Development Facilitation Team (DFT) – Review Comments

Project No: PR-2021-005151 Date: 08/23/2023 Agenda Item: #10 & 11 Zone Atlas Page: A-12

Application For: SD-2023-00124-PRELIMINARY PLAT (DHO)

Project Name: Paradise Heights, Unit 1

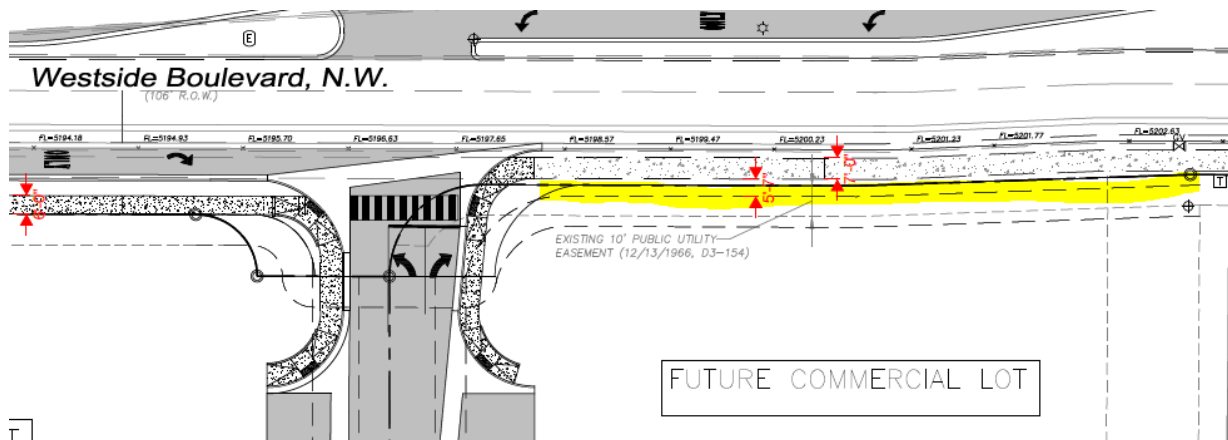
- An easement or ROW is needed for the landscape buffer (5 feet 7 inches) shown below:
